**CRITICAL DESIGN REVIEW
UH-1N HELICOPTER RESCUE HOIST**

TECHNICAL REPORT ASD-TR-73-25

JULY 1973

AERONAUTICAL SYSTEMS DIVISION
AIR FORCE SYSTEMS COMMAND
WRIGHT-PATTERSON AIR FORCE BASE, OHIO

UPPER WINCH MOUNT

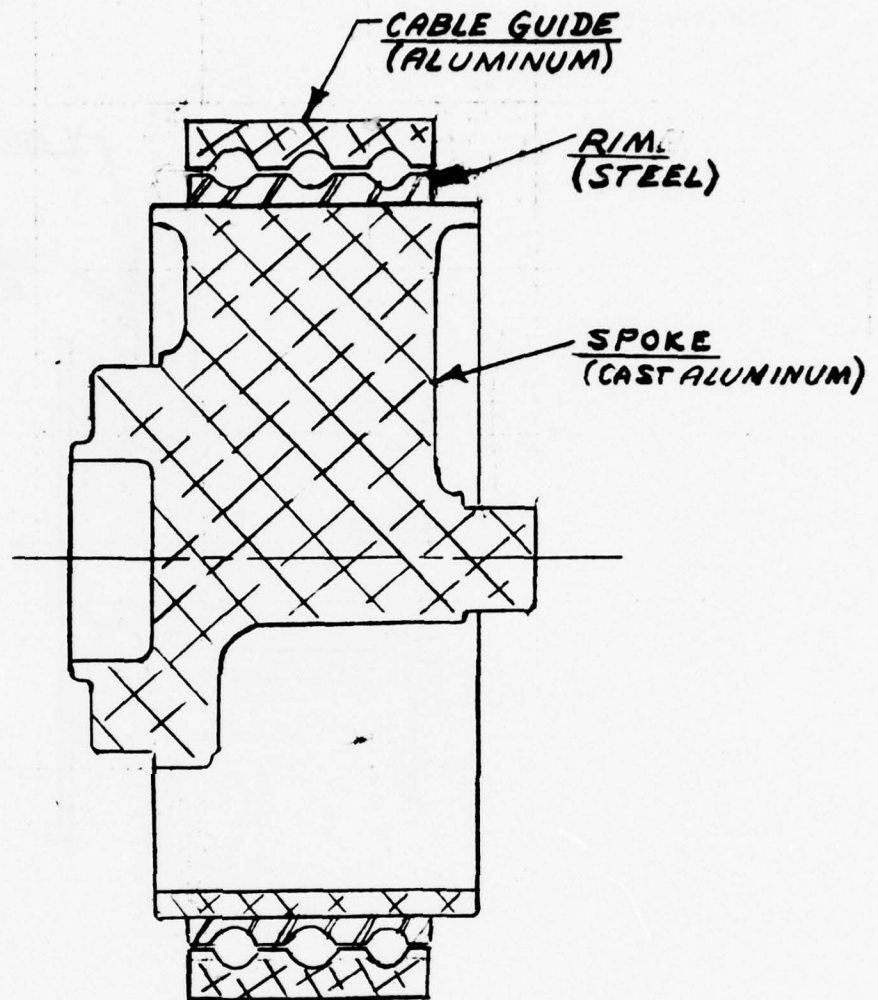
(4) Winch-to-Mast Connection - The brackets which facilitate mounting the winch on the vertical mast have been analyzed and found to be structurally adequate. It was determined, however, that a potential cable snag area is formed by a hex head bolt in the top mounting bracket (Fig 2). This condition can be corrected by substitution of an oval head machine screw.

(9) Upper Winch Mount - Replace the hex head bolt in the upper winch mount with an oval head machine screw to eliminate a pocket for potential cable fouling (Fig 2).

SECONDARY CAPSTAN (SECTION)

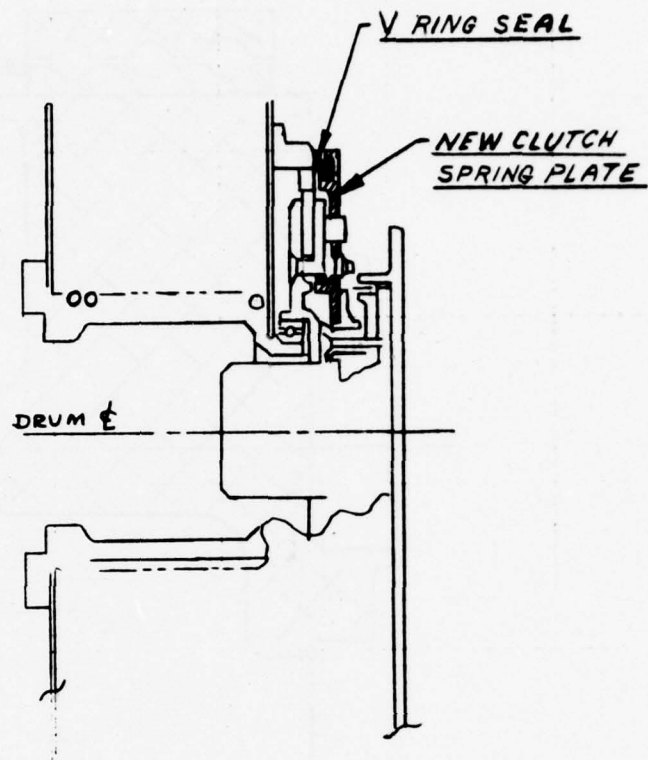
(c) Corrective Design Change - The in-house review team and Breeze Corp analyzed the failures described in (a) and (b) above. The out-of-tolerance condition was considered a possible cause for the lateral rim slippage but was discounted as a reason for spoke failure. Excessive winch bearing mount deflection was also considered as a potential cause of both the spoke failure and the rim slippage. This consideration was based on the fact that original winch qualification (endurance cycling at high load) was conducted at Breeze Corp with the winch mounted on a relatively massive test fixture. The CDR testing was conducted with the winch mounted on the relatively flexible mast. It was agreed that verification of such a theory would require additional extensive testing. The correction that appeared most promising was incorporation of a steel capstan of heavier section than the present cast aluminum/steel design.

(2) Secondary Capstan - Incorporate a steel secondary capstan in the winch to replace the existing aluminum and steel unit (Breeze P/N BL-5164). Configure the grooved surface so that the need for a side spacer (P/N BL-8079) is eliminated.

STORAGE DRUM CLUTCH SEAL (SECTION)

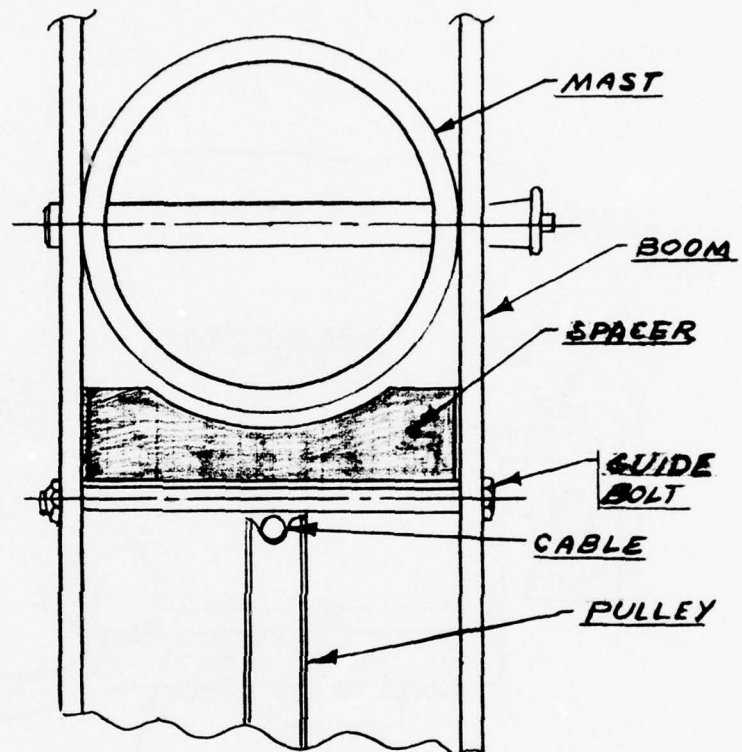
(a) Cable Spooling - When foreign material, such as water or grease, infiltrate the clutch area, the tensioning function of the clutch deteriorates to the point where the cable spools on the storage drum. This spooled cable can, and does, loop over the drum flange and fouls/binds when cable is subsequently payed out. This binding action creates excessive tension which finally severs the cable. Entry of foreign material can be stopped by installing a permanent clutch area seal (Fig 4).

UP LIMIT SWITCH

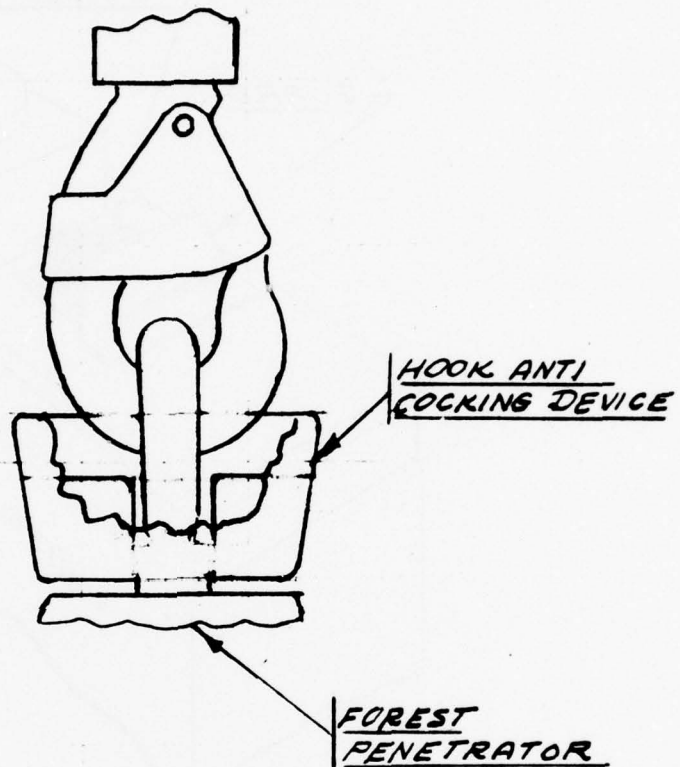
(c) Corrective Design Change - Considering the above, it is apparent that a rather extensive up limit switch assembly redesign is required to insure near fail safe performance. A design of this type would incorporate full redundant electrical circuitry, would not be adjustable in the field, and would have rugged construction to resist deformation. One such design is schematically depicted in Fig 6.

(1) Hoist Up-Limit Switch - Redesign the hoist up limit switch to provide partial mechanical, and full electrical, redundancy (including the control box power relay), to eliminate field adjustment, and to provide more structural integrity. See Fig 6 for a schematic depiction of design features and Section II for rationale.

ANTI COCKING DEVICE

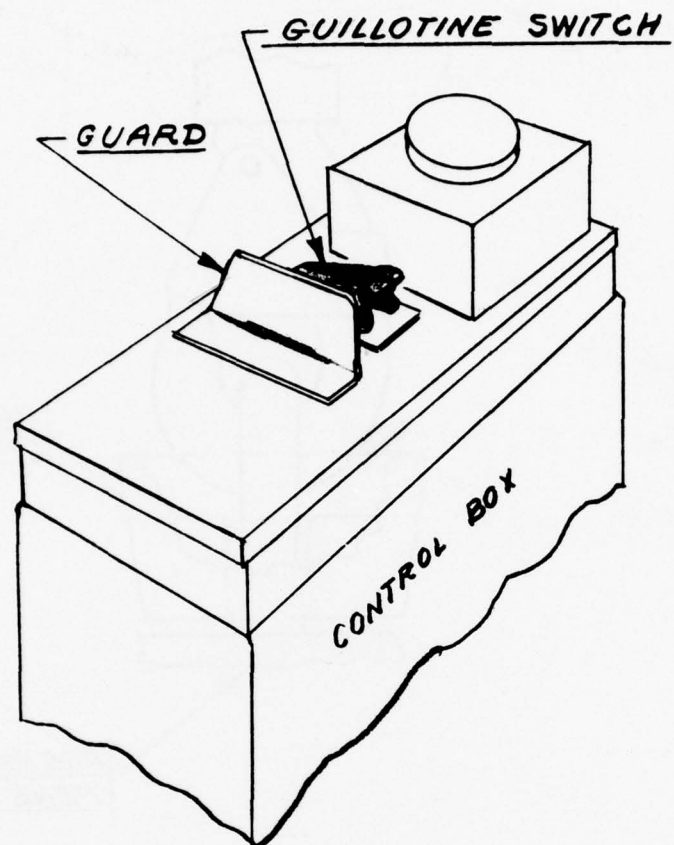
(7) Hook Anti-Cocking Device - Provide hook anti-cocking devices for use with the forest penetrator (Fig 7). This device will reduce an adverse cable loading condition caused by a sharp bend at the ball end fitting.

GUILLotine SWITCH GUARD

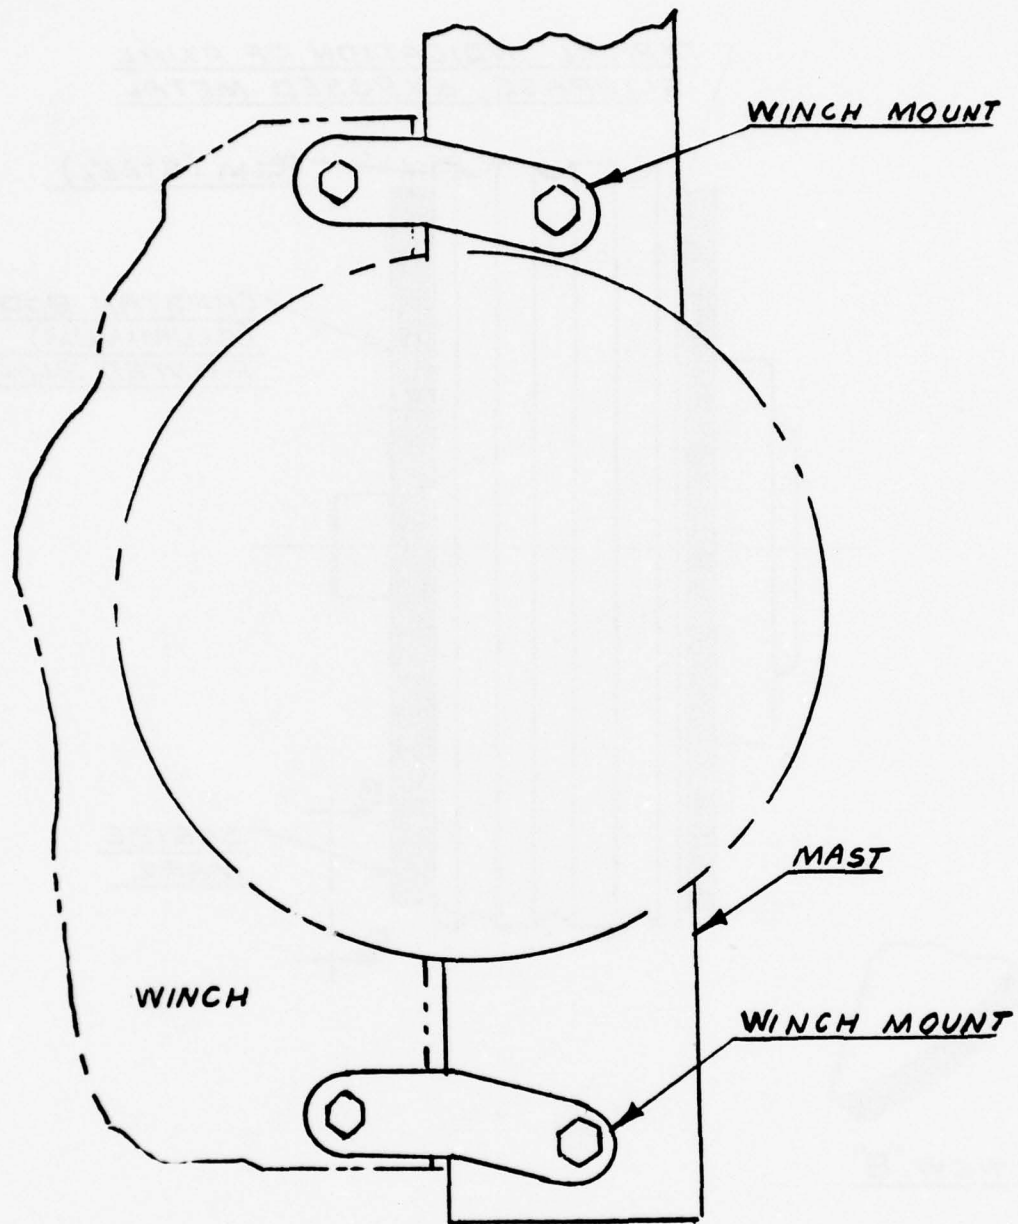
(4) Guillotine Switch - Add a guillotine switch guard as generally depicted in Fig 8 to protect against inadvertent operation.
